MINUTES OF THE MEETING

September 16, 1999

WSCTC - Expansion: Ninth Avenue & Pike Street
Lighting Plan
Lobby

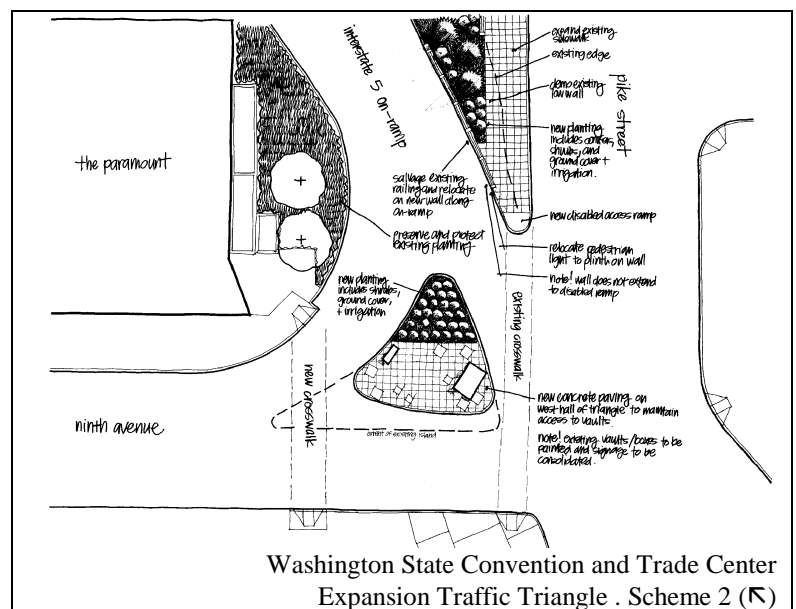
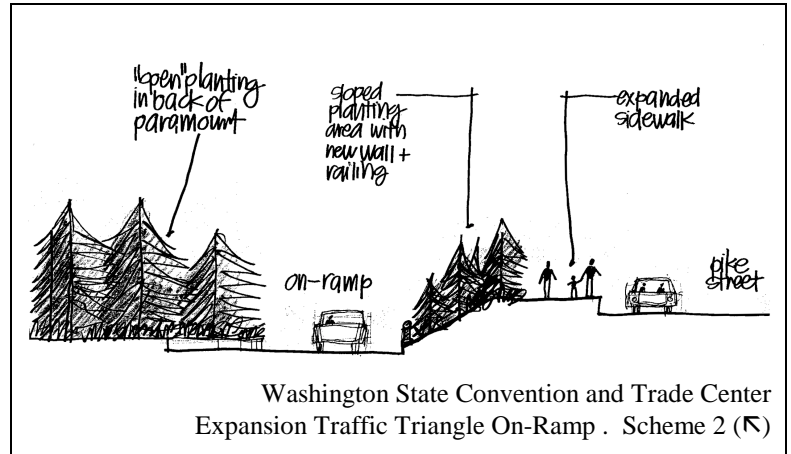
Jaso: Will the island provide a landing point for pedestrians crossing Ninth Avenue along the north side of Pike Street?

Jaso: Will the large blinking express lane sign be removed?

Dubrow: What street vacation condition is this project responding to?

Dubrow: It would be helpful to have a perspective drawing looking back toward the corner of the building and the intersection. This drawing could help inform our decision of whether improving the corner directly at the building would be the way to go, or is this view outward to the connective streets the right direction.

Dubrow: Do you have a preferred alternative?

Nakano: Should we express the decorative paving pattern or should it reflect the standard city two by two grid?

- Foley:** I think it's wonderful that you are considering the treatment along the on-ramp and that it is very meaningful with regard to the corner condition. Further, planting along the on-ramp lessens the need to plant the island. I think it is important to treat the area along the south façade of the Paramount Theater. Additionally, as you look at the island, consider the possibility that pedestrian traffic heading west on Pike Street may also want to go north on Ninth Avenue. This scenario favors the scheme that is less heavily planted and has better sight lines.

- Jaso:** I agree that if I am approaching the island from the west, I don't think I would feel invited to stop if it is covered with plantings. As a pedestrian, I would like the option to stop on the island. I'm not suggesting that the entire space should be paved, but I think we should encourage the design team to claim as much space for the pedestrian as possible.

- Jaso:** Regarding the new crosswalk on the north side, does it make more sense to cross diagonally through the island and over to the retail corner rather than straight across just west of the island?

- Layzer:** It would make sense to extend the triangle into the existing Pike Street crosswalk with ramps on either side so it becomes a formal landing that could possibly slow down the traffic heading east bound on Pike Street?

Mather: In the fourth alternative schemes, we have incorporated planting and paving in order to allow for pedestrian access. In this scheme we do not have any planting but do attempt to tie in the circular decorative paving pattern along Pike Street onto the island.

Mather: We have refined our second scheme to include a combination of planting and paving that allows for pedestrian access across Ninth Avenue to the Paramount Theater. The Department of Transportation wants to implement a crosswalk at the Paramount Theater edge. We have also tried to integrate some tiered planters similar to the ones at the Convention Center. And, in a continuing effort to better unify the area, we may try to redo all of the planting in back of the Paramount Theater.

Mather: I think it is important to maintain some planting and paving so I prefer the fourth alternative that combines both.

- Action:** **The Commission appreciates the presentation and makes the following comments and recommendations.**
- **The Commission feels this is a reasonable response to the conditions;**

- **supports the decision to extend the plantings along the I-5 express lane on-ramp;**
 - **supports the notion of giving priority to pedestrians over plantings on the island, but encourages a mix of landscape and paving;**

- **recommends minimizing the number of crossings to the convention center and urges a move toward stronger connections by utilizing the pedestrian island; and**

15th Avenue East and East Harrison Street Small Family Apartments . Proposed Site (→)

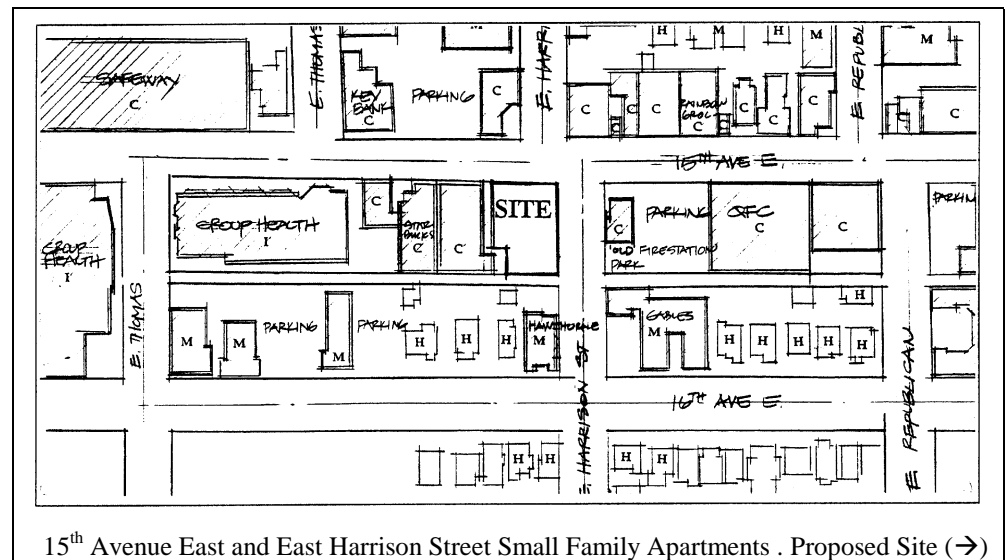
- Dubrow:** You presented a wide variety of examples of what currently exists on this street and I am eager to hear what you consider to be the strengths and patterns that you will draw from.
- Hale:** There is a common thread of bay windows and fine detailing of the local structures that we hope to emulate.
- Layzer:** I appreciate the extensive analysis you have done and would encourage you to trust your intuition. You have a diversity of materials on your palette that can serve you well.

Rahaim: It seems important to take care in how the building sits on the corner. It will appear taller than other buildings on the street and could potentially take on a landmark quality.

Girvin: I am pleased with your acceptance of the existing landscape easement and the possible development of a related courtyard. If you think children will reside in the building, the consideration of a passive outdoor space where children can go is a good one.

- **The Commission appreciates the thoroughness of the analysis of the site and surrounding context;**
- **is enthusiastic of the plans for mixed use at the site and the general approach;**
- **wants to reinforce the importance of the small landscape element within the site as well as the distinction between commercial and residential treatments.**
